DESIGN REVIEW BOARD

November 14, 2016

DRB2016-20

Design Review for new construction of an office building and associated site work.

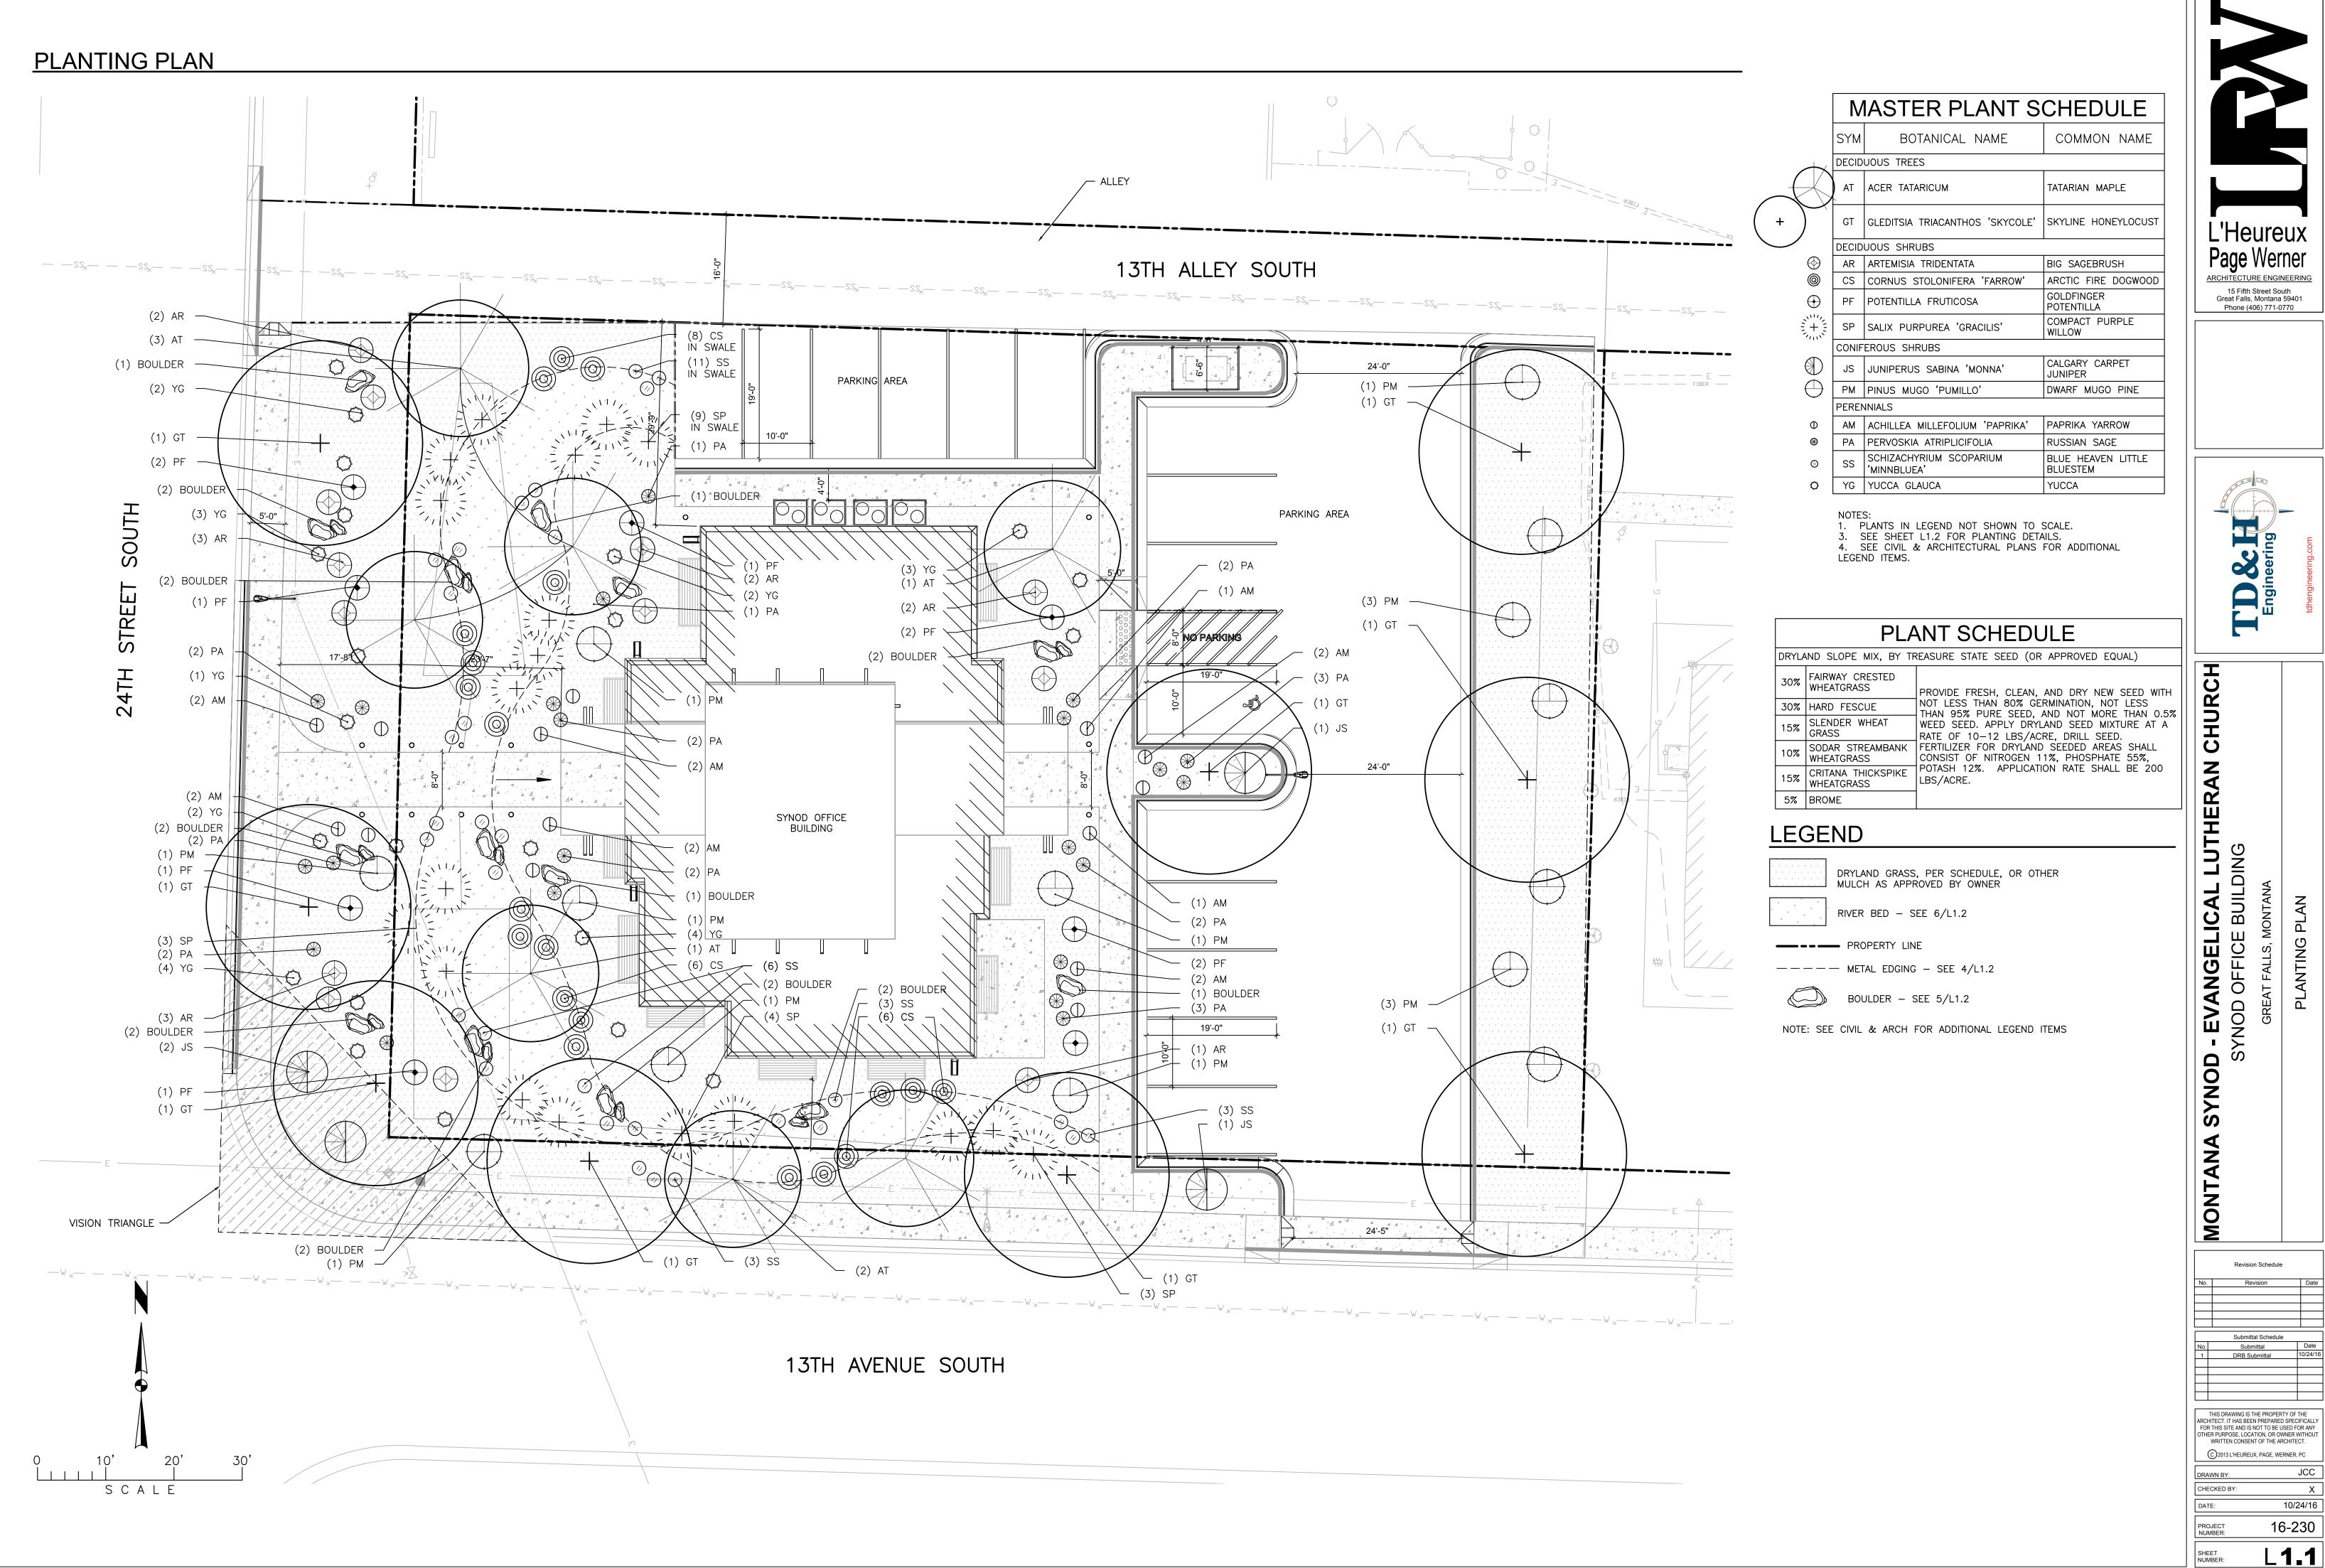
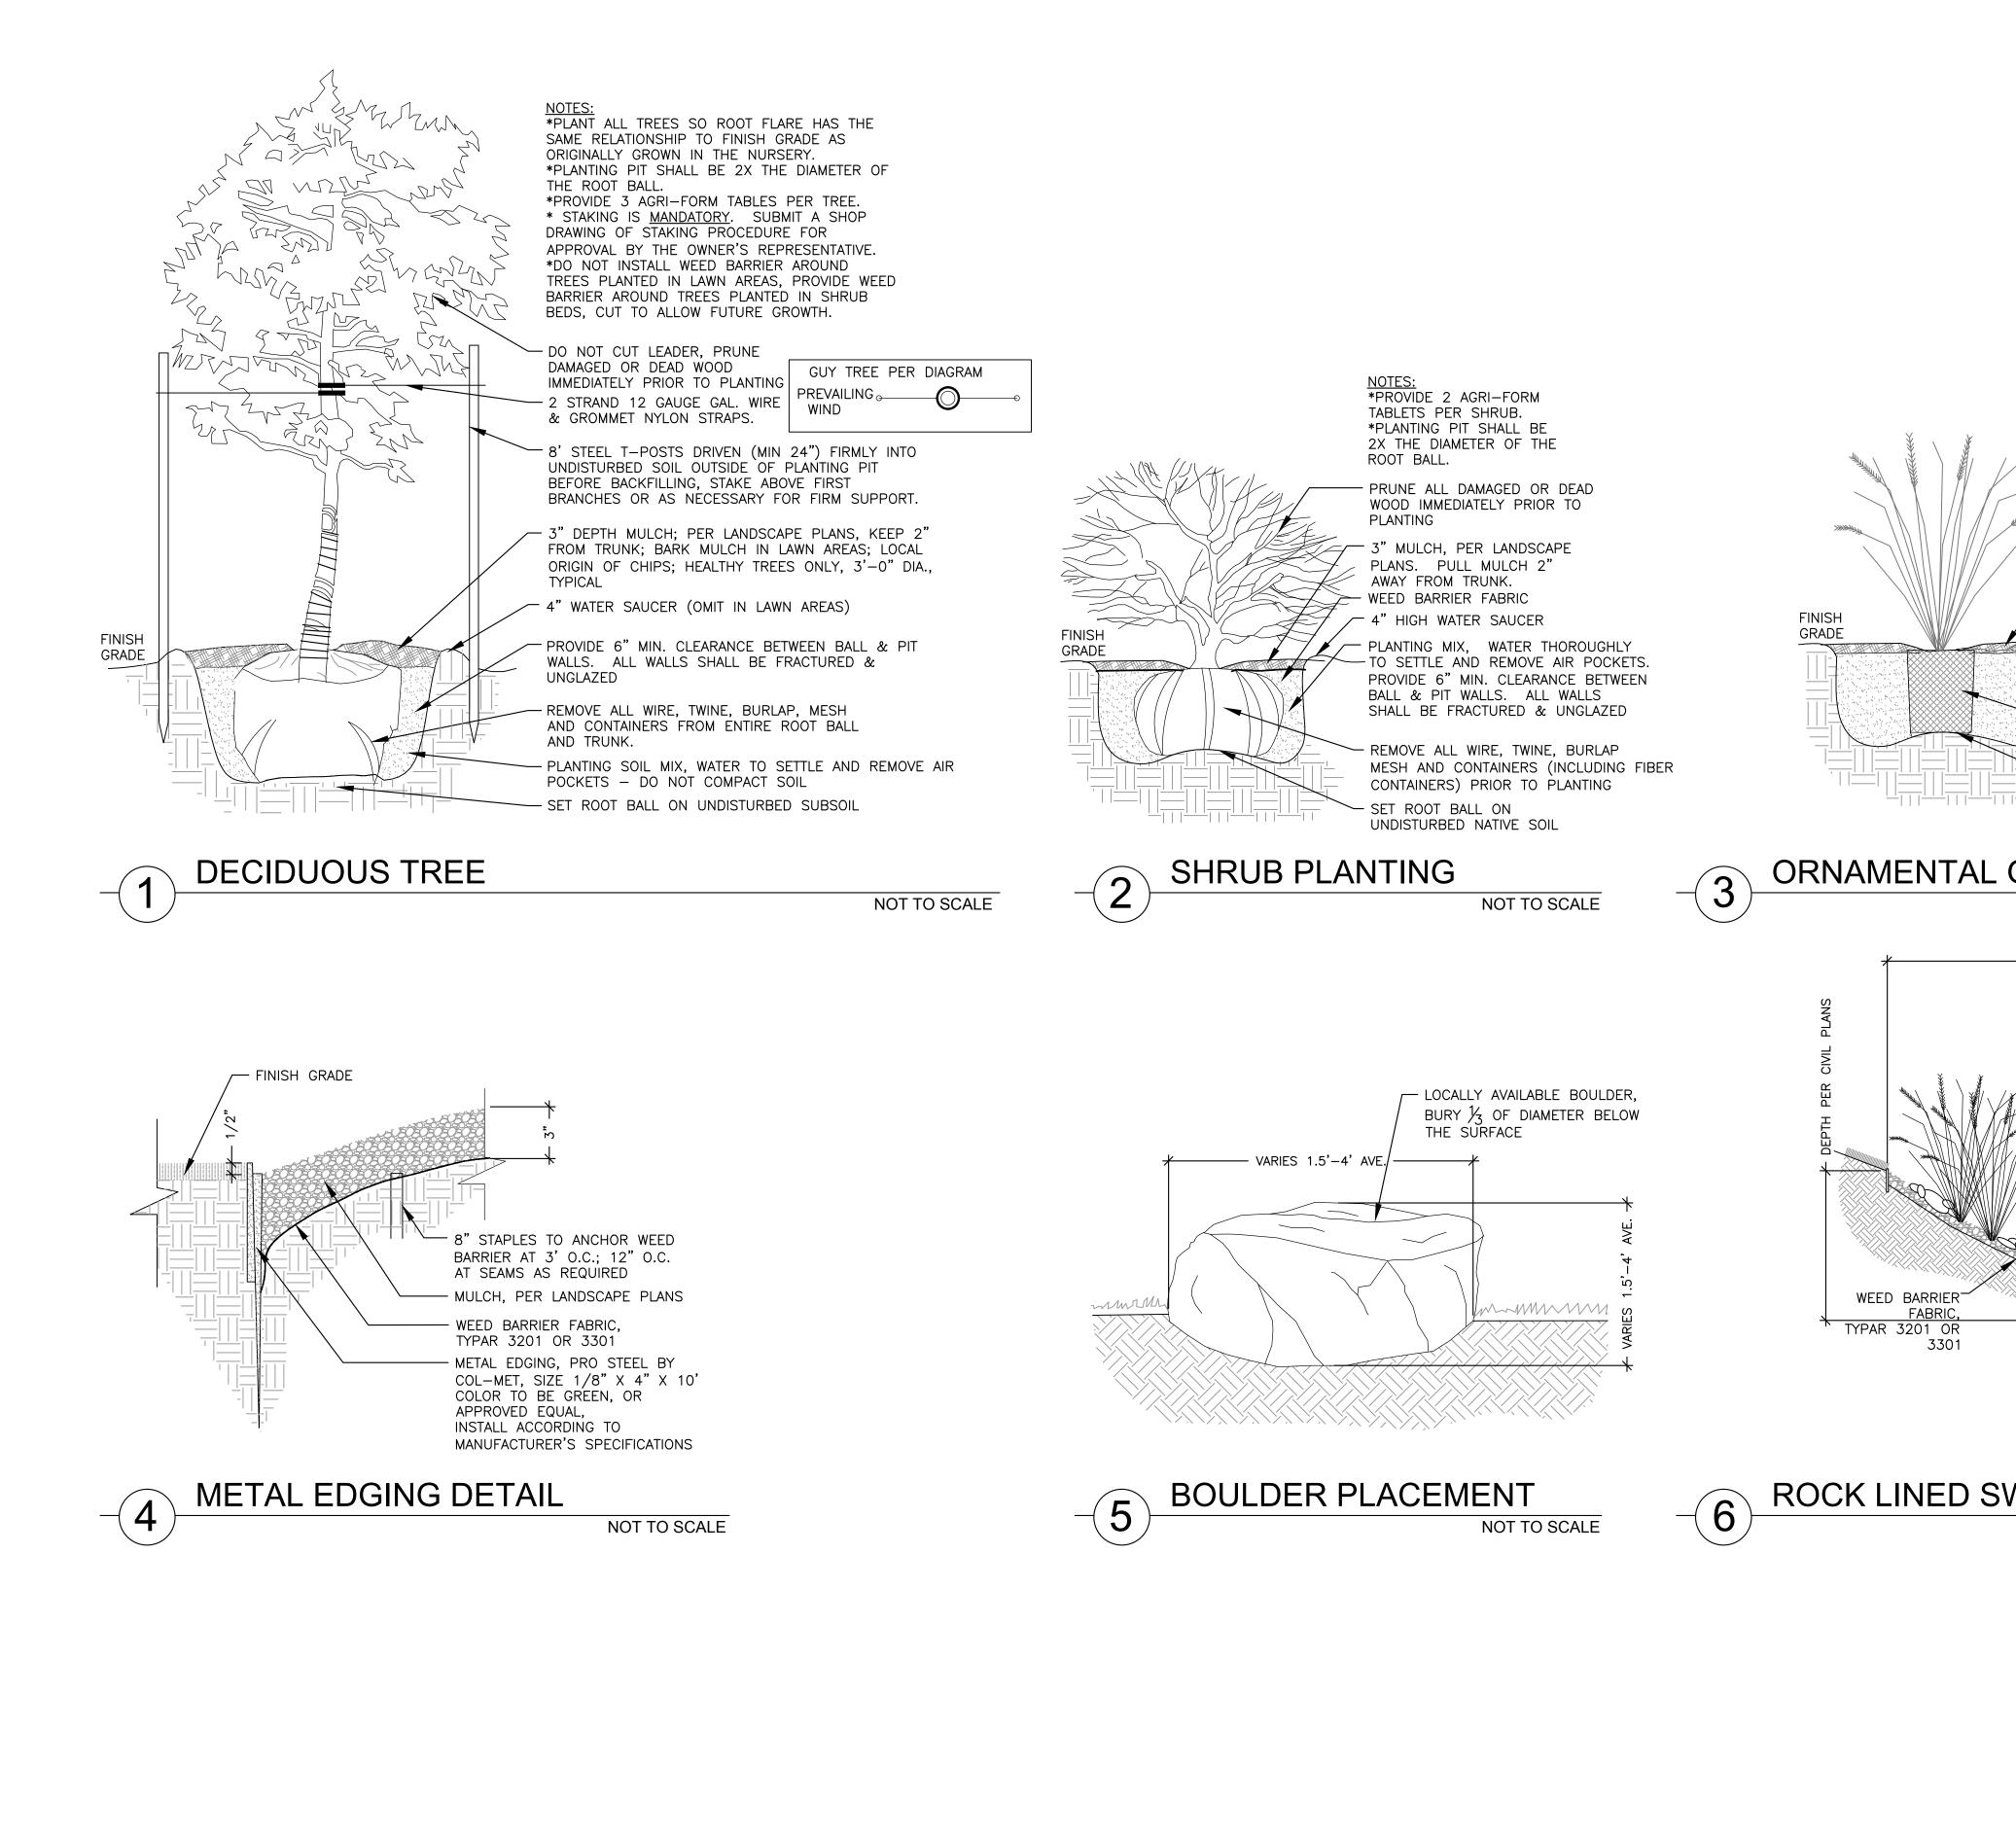
The proposed landscaping requires modification to meet the minimum requirements of the OCCGF. Paved or nonliving surfaces are the dominant texture within the interior of the site, with cement walkways accessing the building from the public right-of-way, an asphalt parking lot, a rock swale to convey stormwater, and rock mulch in all landscape beds. The exterior of the site will be significantly improved by landscaping including grass, canopy trees, shrubs, and perennials.

The OCCGF Chapter 44 - Landscaping, requires that 15% of gross property area is required to be landscaped. It further requires a minimum of one (1) tree and seven (7) shrubs planted and maintained per four hundred (400) square feet, or fraction thereof, of required interior landscaping, as well as 1 boulevard tree for each thirty-five (35) lineal feet of street and avenue frontage. For this site, there are 9 boulevard trees, 8 interior trees and 55 shrubs required to be installed. The landscaping plan submitted meets the required rate of planting, but does not meet the required boulevard trees required. Also, due to the requirement of the boulevard-style sidewalks, the placement of boulevard trees will need to be revised. The proposed landscape plan also shows that the site would be seeded with a dryland seed mix instead of turf grass. The OCCGF requires turf grass is to be installed in the right-of-way, Staff recommends that the whole site be installed with turf grass in order to first be consistent with the surrounding properties and second to ensure establishment and prevent erosion on site. Chapter 44 requires that each row of parking in interior parking areas shall be terminated by a landscape island. The parking island located at the end of the parking lot that contains the trash enclosure must also include landscaping instead of all concrete. Finally the OCCGF requires that all commercial buildings shall use at least 50% of the building frontage for foundation plantings as well as at least 20% of the sides of the building. Since the department of Public Works requires that all plantings except for the boulevard trees be moved on-site, this plant material could be relocated as foundation plantings. The landscape plan has been sent to the City Forester for review and any comments will be reflected in the revised landscape plan.

- G. The applicant shall install turf grass rather than dryland grasses.

- Applicant shall revise the site plan to show boulevard style sidewalks on 24th Street South.
- Applicant shall revise the photometric plan to meet the illumination level at the property boundary line.
- Applicant shall revise the photometric plan so that the maximum average light levels shall comply with Exhibit 40-1.
- Applicant shall revise all shrubs on the landscape plan to be specified at two gallon container grown or greater.
- Applicant shall revise the landscape plan to comply with required boulevard tree counts.
- The applicant shall revise the site plan and landscape plan to show all parking be terminated with a landscape island.
- Applicant shall revise the landscape plan to show the required foundation plantings.
- Applicant shall revise the landscape plan to show that turf grass shall be installed in the right of way.

1 SITE LIGHTING PLAN

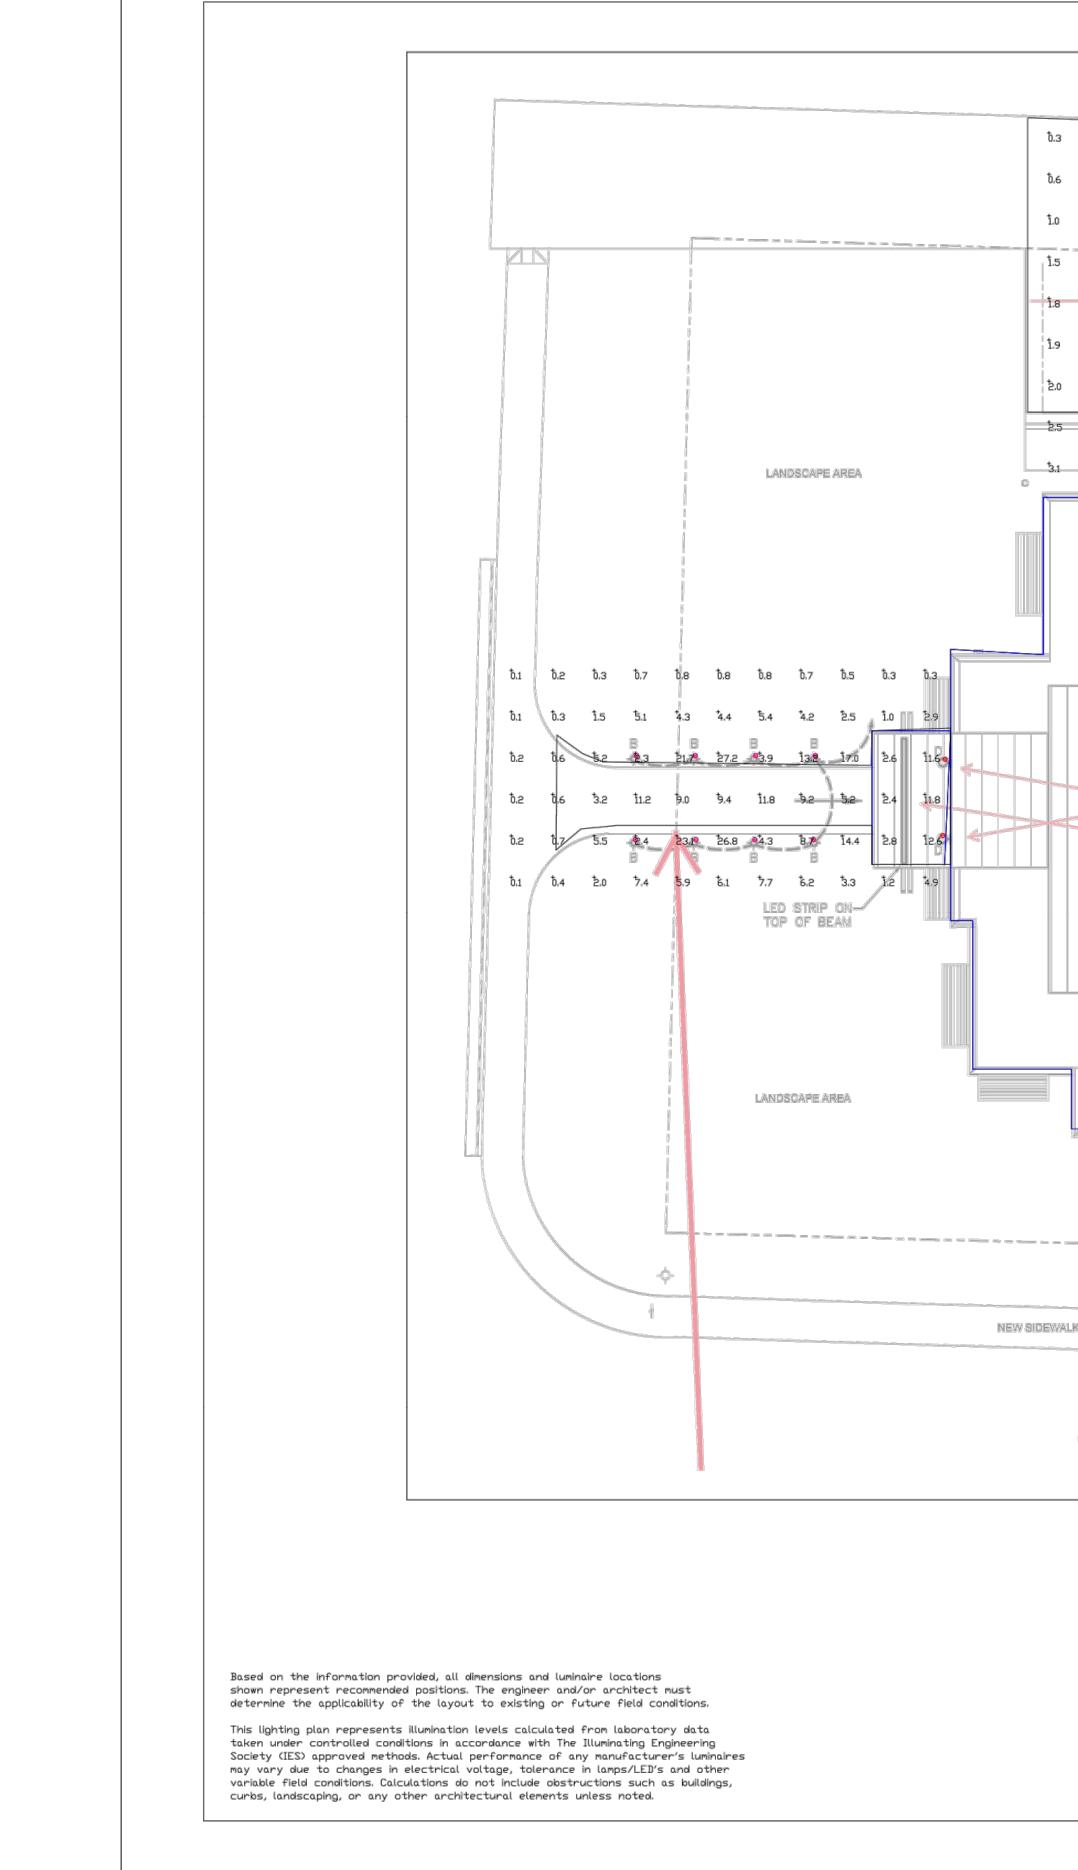
The applicant has provided an outdoor lighting plan which requires modification in order to meet the intent of the OCCGF. First, the applicant has proposed lighting in the public right of way. All work proposed in the Public right-of-way must be approved by Public Works and they require these lights be moved out of the right-of-way. Per Exhibit 40-1 in Chapter 40 - Outdoor Lighting of the OCCGF, sidewalks and other pedestrian walkways cannot exceed the average lighting levels of 3.0 foot candles. The photometric plan that has been submitted shows an average of 7.91. Also, the photometric plan is not showing an average for the entry to the buildings. Both of these items are required to be addressed per Title 17. Even though the parking lot average is under the 5.0 foot candle requirement, the plan shows a light level in the parking lot over 30 foot candles. There are several purposes of the lighting chapter of the OCCGF, one of which is to allow appropriate lighting levels to preserve safety, security and nighttime use; but is also looks at reducing light pollution and creating dark sky friendly development. Staff will require that the maximum light levels be reduced. Finally, when a commercial use abuts a public right-of-way or another commercial use the foot candles at the property line cannot exceed 1.0 foot candle. These deficiencies of Title 17 shall be revised on the photometric plan.

- C. The applicant shall amend the site plan to show screening for the AC condensers.
- D. The applicant shall revise the photometric plan to show lower foot candle levels in the parking lot.
